**PLANNING COMMISSION MEETING
MUNICIPAL CENTER COUNCIL CHAMBERS
Tuesday, May 3, 2016**

4.A. Request Revised Landscape Plan Approval for Somerset Subdivision

4.B. Riverdale Elementary School, 7391 Neshoba Rd. – Request Revised Preliminary and Final Site Plan Approval

4.C. Request Outline Plan Approval of Pike View Estates PUD

RE: Somerset Subdivision – 15-513
Revised Landscape Plan
Germantown, TN 38138

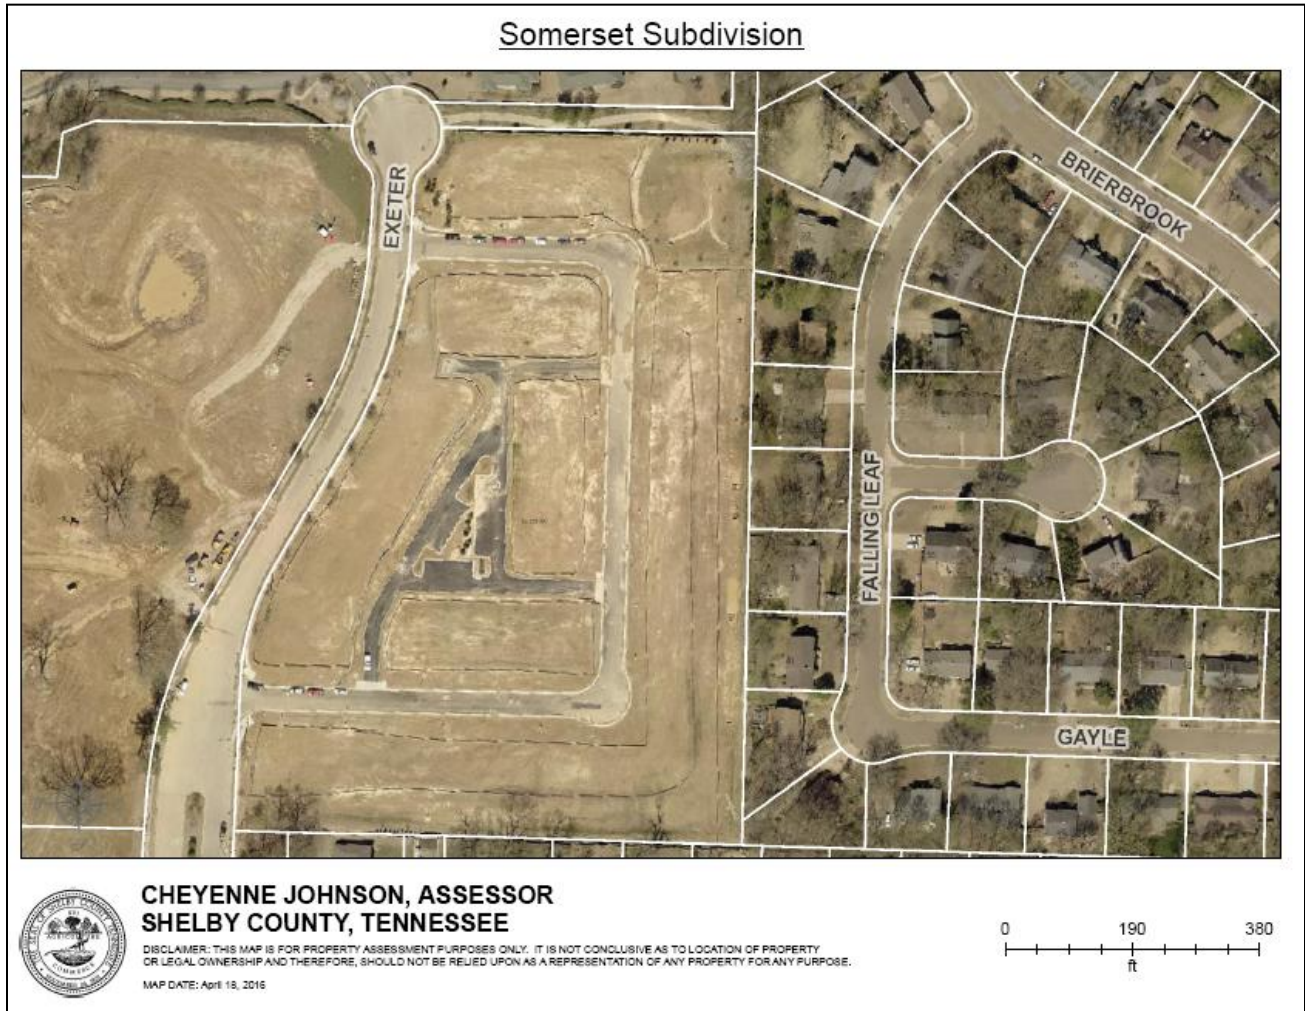
Based on the proposed submitted revised landscape plan provided by Regency Homebuilders, LLC, it is the opinion of the DRC members of the Smart Growth subcommittee that the plans submitted meet the requirements of the DRC in regard to plant materials, sizes of plants and arrangements of same. Further, the reason for the change in the original landscaping is a valid reason for change, ie, overhead power lines above the landscaping area along the street. It is currently the DRC policy to use planting materials that prevents the growth into the power lines causing the plants to be cut back producing an unshapely appearance.

It is also the opinion of the members that all brick walls and columns proposed to be used within the landscape areas should all be constructed with proper vertical reinforcement from the footing into the brick wall or column itself to aid in the prevention of till over.

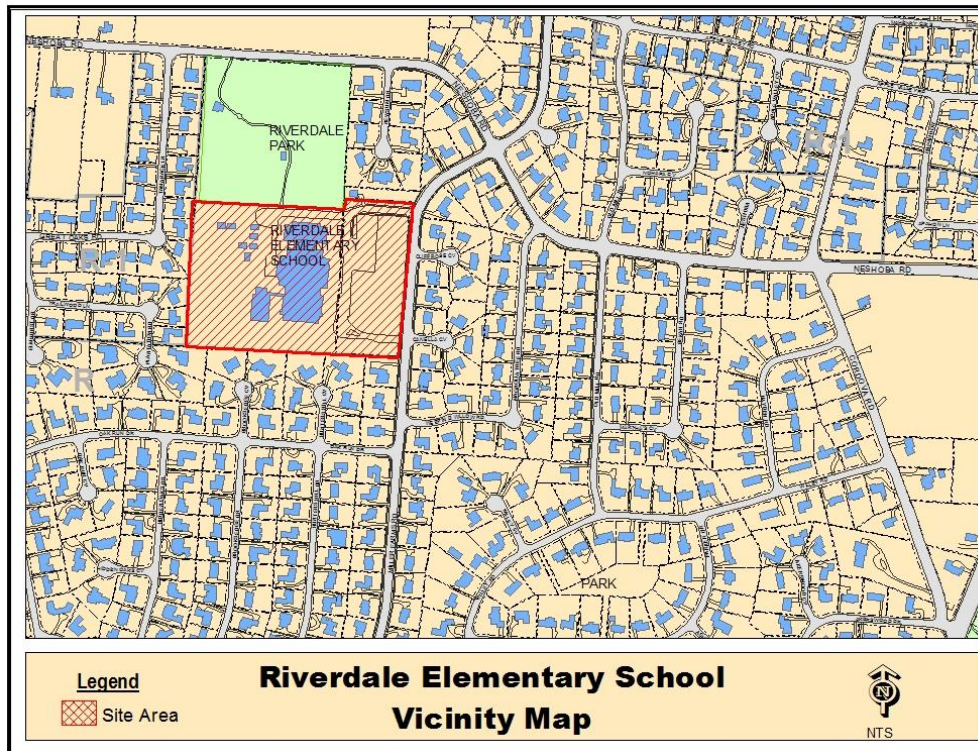
1. Emergency vehicle access is subject to approval of the Fire Marshal.
2. Show radius on the entrance drive and the corner of the grass pave area for fire truck turning on the site plan.

3. The entrance drive should be shaded to reflect this as a fire access drive. Also designate this area as “Heavy Duty Pavement”.
4. Fully dimension all areas of the parking lot for construction layout on the site plan, including curb radius. Typical width of parking spaces should be 10’ for 180 square foot parking space.

5. Provide information on what type of curb to be used in parking lot and spot elevations
6. Identify black objects between some of the parking spaces that are shown on the site plan.

7. Provide spot elevation on the Grading and Drainage plan.
8. Provide elevation of all finished grades.
9. Note: curb is to be flush with grass pave.
10. Show direction of drainage flow.

11. Entrance drive to parking lot is to be flush with existing asphalt.
12. Provide information on need for turf mat and rip-rap.
13. Lighting and landscaping for the parking lot to be approved by the Design Review Commission.
